Re: Sub-Petition No. 1293-MI-01 - Request for Access Road Change in Middletown

1050 LINE STRUCTURE REPLACEMENT PROJECT

Sub-Petition Map Set
 FINAL - January 8, 2019

Middletown, CT
 Page 2 of 13

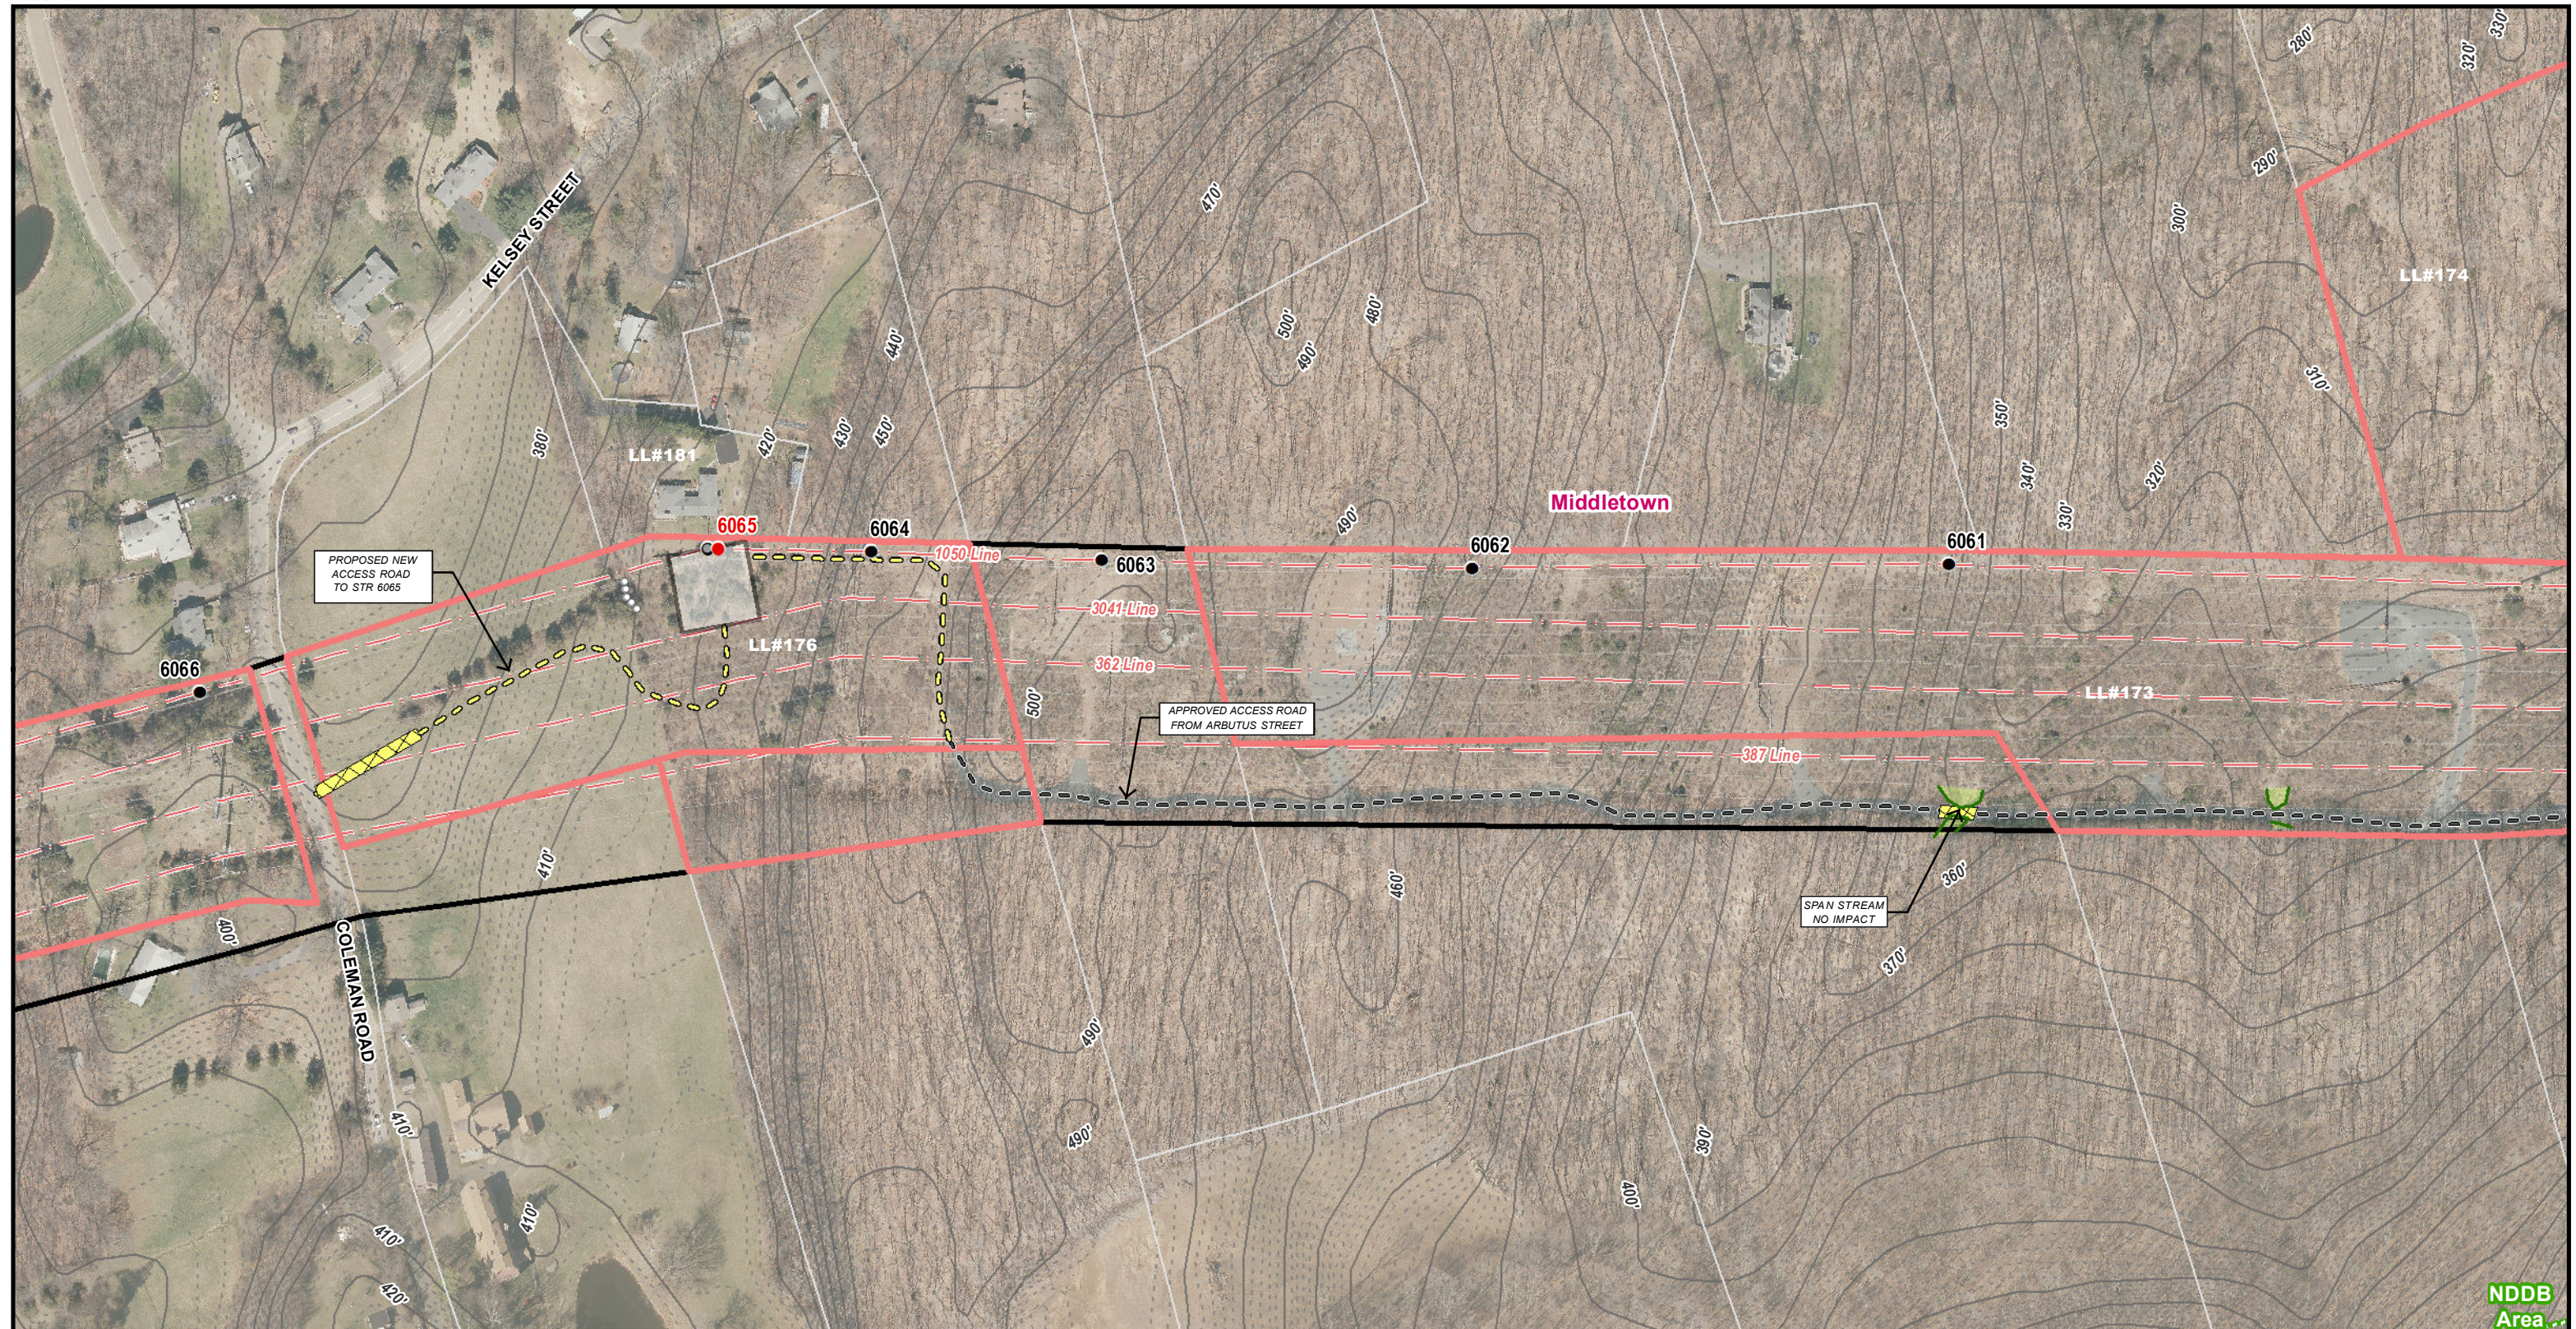
Change in Access Road from Arbutus Street to Coleman Road in Middletown for structure #6065

The location of this requested change is located in Middletown off Coleman Road just south of the intersection with Kelsey Street. This location is shown as “Proposed New Access Road” on the revised Map Sheet 2 dated January 8, 2019 (see Attachment A).

In the sub-petition filing, Eversource had shown access to structure 6065 by entering the Eversource ROW off Arbutus Street and traversing the ROW utilizing both an existing and proposed access road. This access would have required spanning a wetland/watercourse area and constructing a new section of access road up a steep hill adjacent to a residential property. After further review, it has been determined that impact to the residential property could be reduced and the steep hill avoided by accessing the ROW from Eversource property off Coleman Road. A portion of the newly proposed access road would be constructed with temporary construction matting to protect a farm field. Upon completion of the project the temporary matting would be removed and the area restored, as necessary. The remainder of the access road would be constructed with gravel and a portion will follow the edge of an existing hedge row that dissects the farm field. The proposed new access road would eliminate the wetland/watercourse crossing, reduce impact to the residential property, and avoid traversing the steep hill.
